(54) Title: METHOD RELATED TO CLOCK DELAY COMPENSATION

### INTERNATIONAL PRELIMINARY EXAMINATION REPORT (PCT Article 36 and Rule 70)

International application No. PCT/NO99/00160

AMENDED SHEET

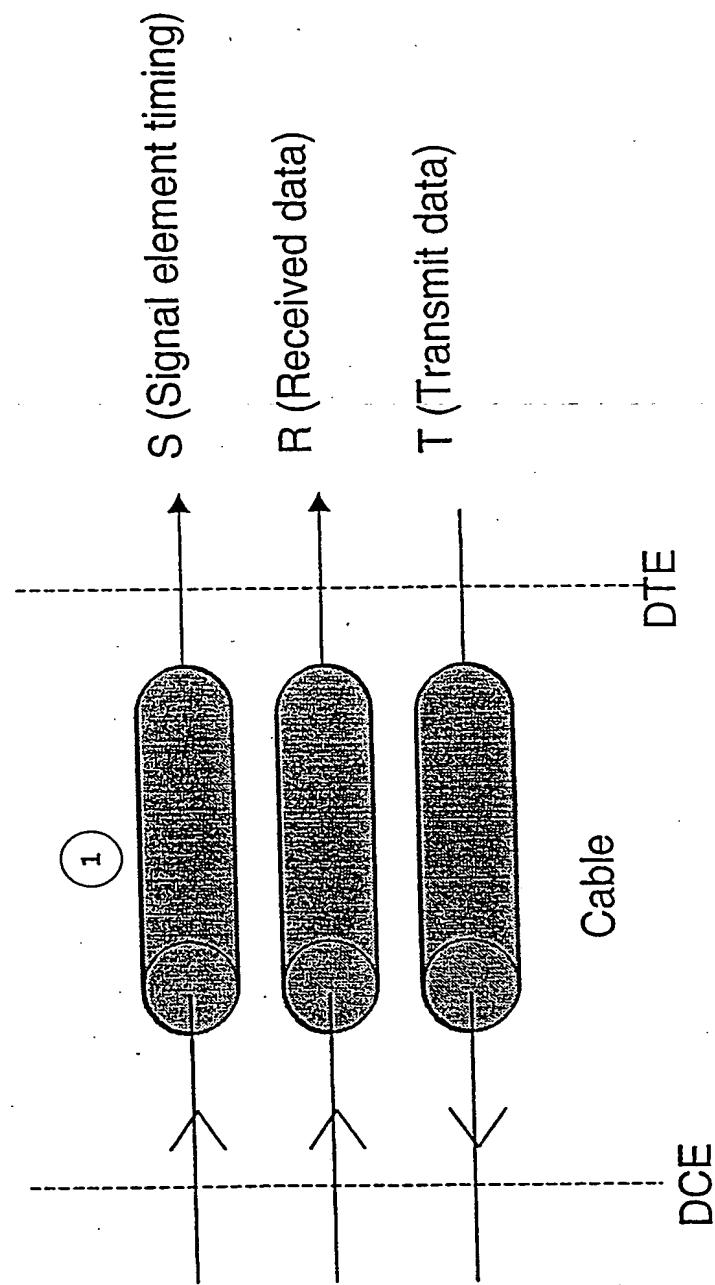
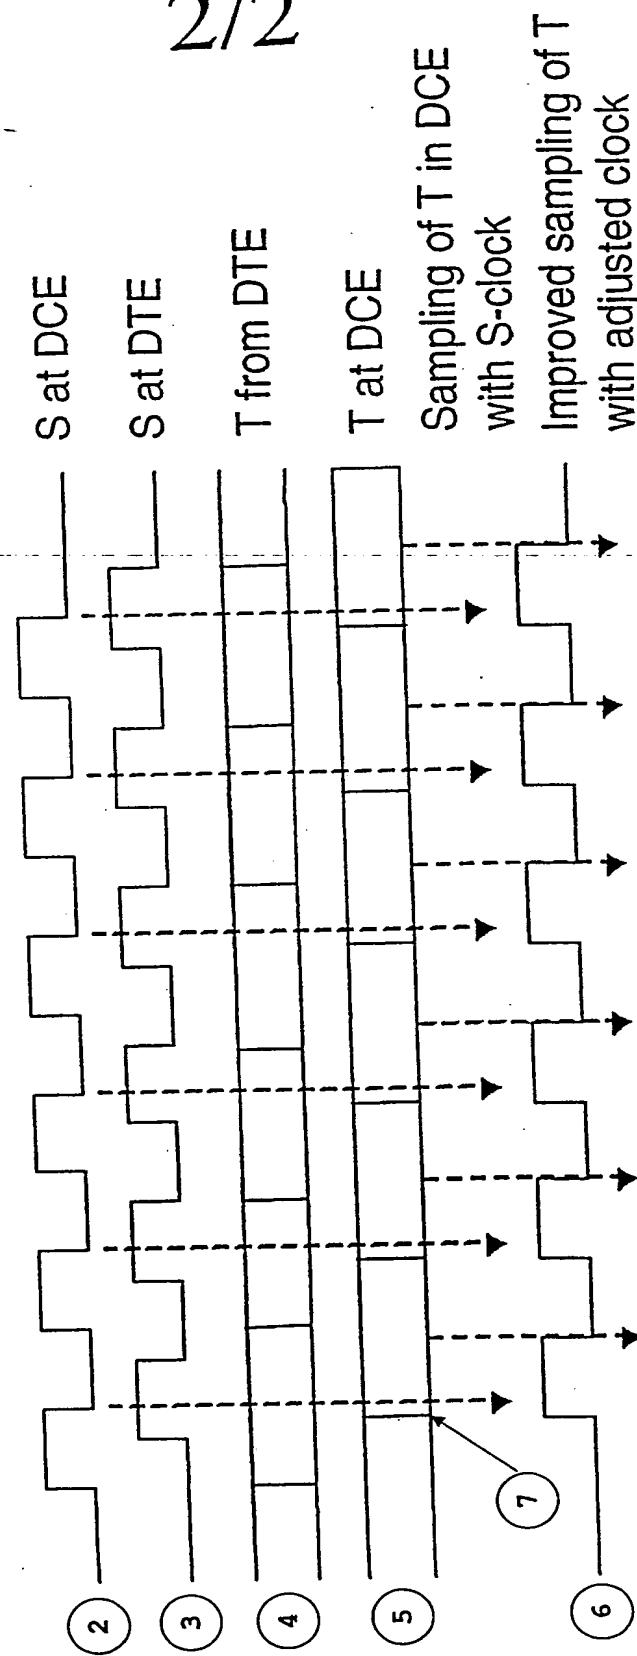
- Elements from the documents in the search report of the written opinion is being placed in the preamble of claim 1
- Reference numerals are added to the claims and the corresponding figures
- Claim 1 is brought into a clearer formulation
- Former claim 2 is included in claim 1
- Some terms and expressions pointed out in the written opinion are removed or replaced
- Documents D1 and D2 are identified in the background art
- The description is brought into conformity with the amended claims

1. Method for compensating a cable delay in transmitted data signals (5) which are sent through a cable (1) connecting data communication equipment (DCE) to data transmission equipment (DTE), the DCE including a counter which controls the data samling at the DCE with a signal element clock, a variable phase clock and a buffer, characterized in that the transmitted data signals (4) are delivered from the DTE with reference to the signal element clock signals including cable delay (3), and that the transitions (7) in the transmitted signal (5) on the DCE from the DTE, also including the cable delay, is used as a reference for resetting said counter for thereby ensuring that data always is sampled in the middle of the symbols of the transmitted signals (5) at the DCE.

2. Method as defined in claim 1, characterized in that the transmitted signals (4) in the DTE are clocked into said buffer with said variable phase clock, and are clocked out with reference to said signal element clock signals including cable delay (3).
